STAFF AMENDED 8-7-91
CITY PLANNING COMMISSION
 1231 "I" STREET, SUITE 200, SACRAMENTO, CA 95814

- A. Negative Declaration
- B. Plan Review to construct a 110,400 square foot warehouse building on 8.8± vacant acres in the Light Industrial- Review (M-1-R) zone

LOCATION: Northeast corner of Raley Boulevard and Santa Ana Avenue

EXHIBIT - A

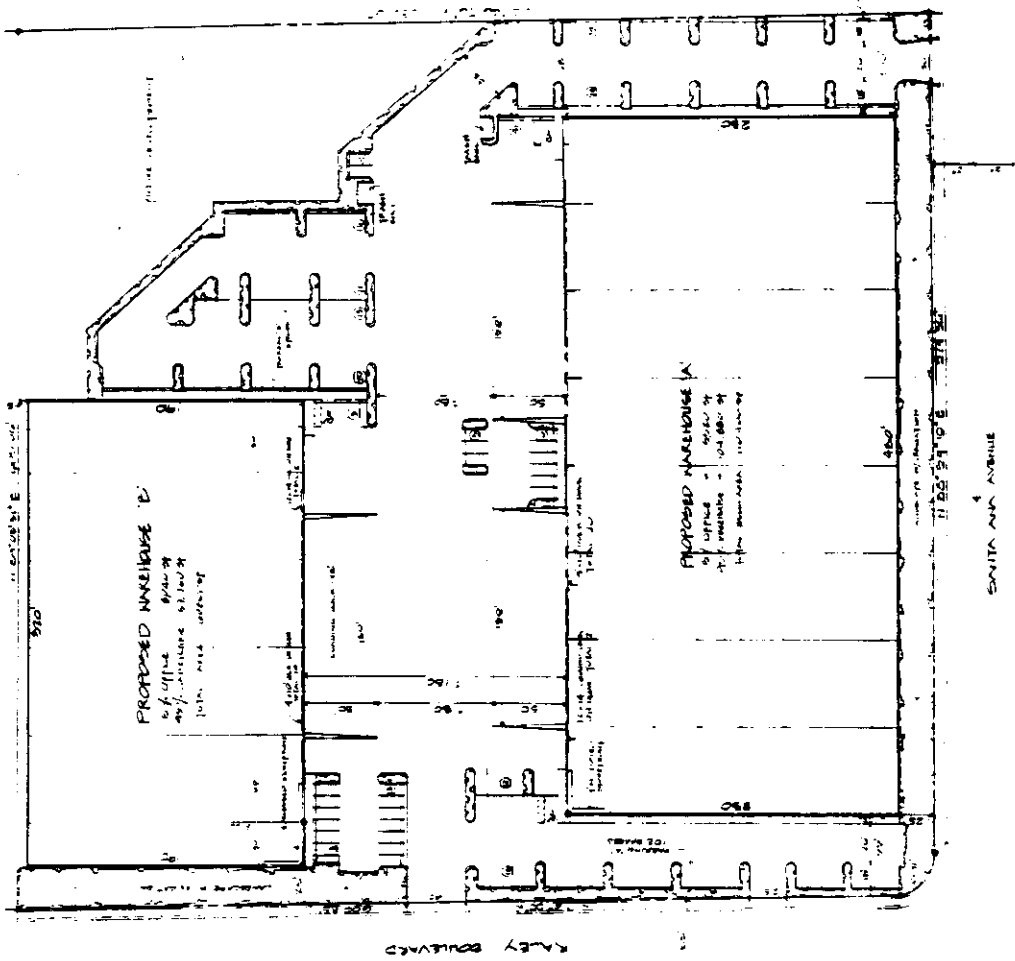
According to the Zoning Ordinance, no setbacks are required in the M-1-R zone. The applicant has proposed 25 feet of landscaping along Santa Ana Avenue and 25 feet of landscaping for a portion of Raley Boulevard. Staff suggests the 25 feet of landscaping be provided along the entire Raley Boulevard frontage. The applicant should submit a revised site plan which indicates this 25 feet of landscaping and the relocation of the required parking. The applicant should also submit a detailed landscape plan for review and approval of the Planning Director prior to the issuance of Building Permits. Staff suggests the 25 foot landscaped areas be landscaped with a combination of turfed undulating berms, shrubs and trees. The site plan also indicates a future development area. This area may not be used for parking or storage of any materials unless it is paved to City standards, and it

should be barricaded with a landscaped planter as indicated on the submitted site plan.

1. Raley Boulevard will be a six lane major street with limited access. No left turn access on to Raley Boulevard from the site. Recommend redesign to provide major access on Santa Ana Avenue; and
2. Comply with the guidelines of the developer TSM ordinance as a "major project".

8. The applicant shall submit a revised site plan which indicates a 25 foot landscape setback along the entire Raley Boulevard frontage and the relocation of the required parking. The revised plan shall be submitted to the Planning Director for review and approval prior to the issuance of Building Permits.

10. The applicant shall provide and maintain landscaping on the five foot strip shown on the site plan between the Phase II warehouse building and the north property line.

11. No parking, driving, or storage shall be allowed on the undeveloped northeast portion of the site. A six inch concrete curb or other suitable barrier shall be provided with the landscaping as shown on the submitted plans to prevent use of the undeveloped portion of the site. The area may be used provided it is paved and landscaped to City standards.

EXHIBIT - B

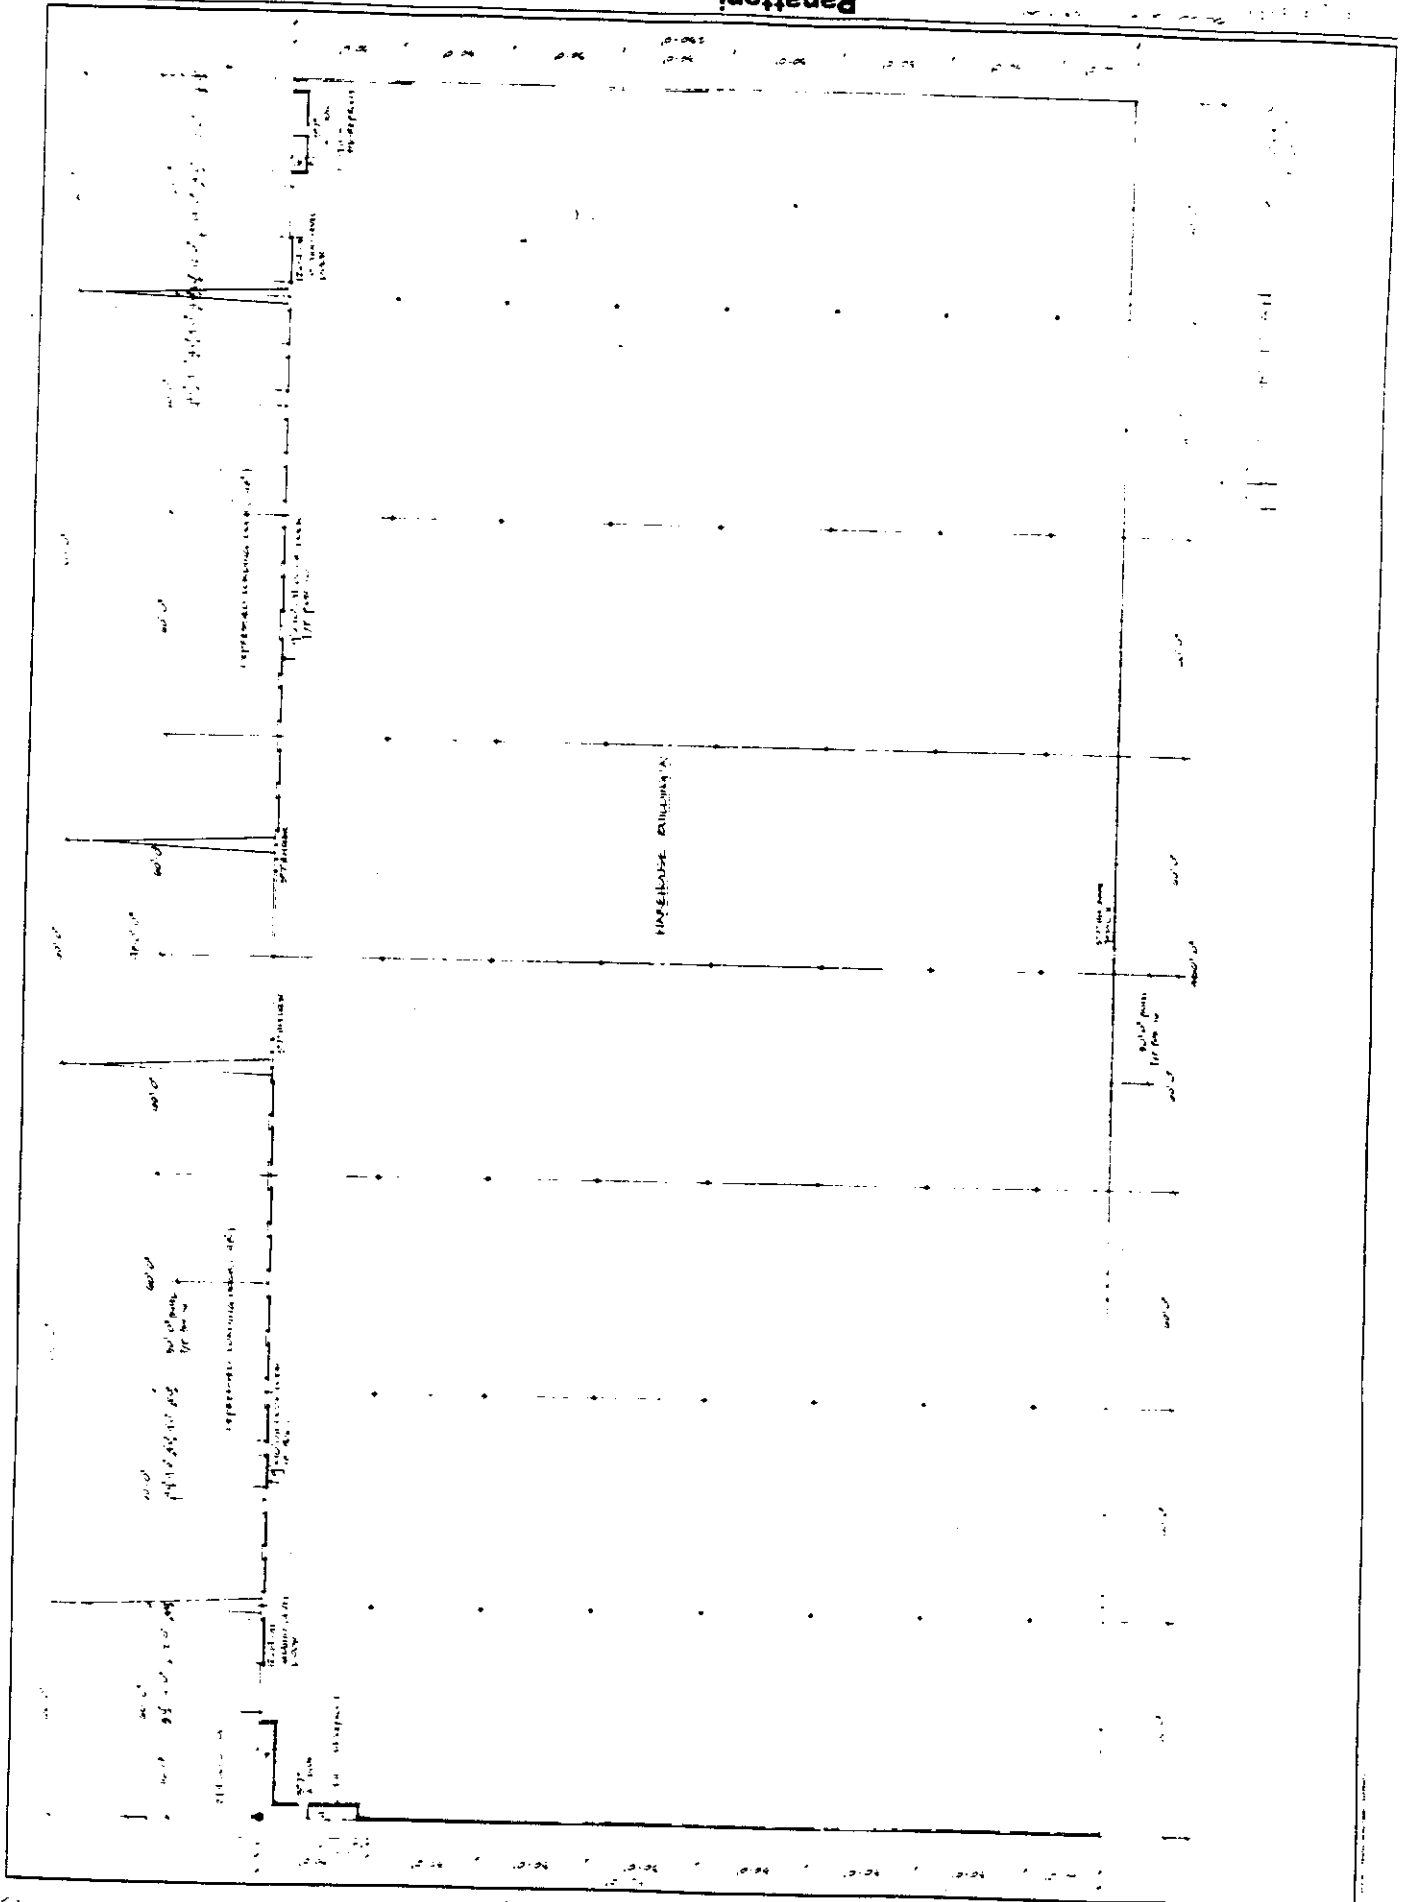
The exterior building materials are proposed to be concrete tilt-up panels with a painted finish. The proposed roof is a built-up parapet roof. The proposed colors are light grey for the walls and doors and orange and dark grey for the three relief stripes. The top and bottom stripe will be orange and the middle stripe will be dark grey. The applicant proposes a 3/4 inch square relief in the concrete panels for each stripe. The applicant indicates striping on all four sides of the building. Design Review staff concurs that each elevation must have the three stripe relief.

4. Each elevation of the building shall have the relief and stripe design enhancement as indicated on the submitted elevations.
5. The office area shall not exceed twenty-five percent of the gross floor area of the buildings on the site. If office area exceeding twenty-five percent of the gross floor area is proposed at a later date, a special permit shall be required. Additional parking spaces shall be required at the ratio of one space for every 400 square feet of office area if additional office floor area is added to the building.
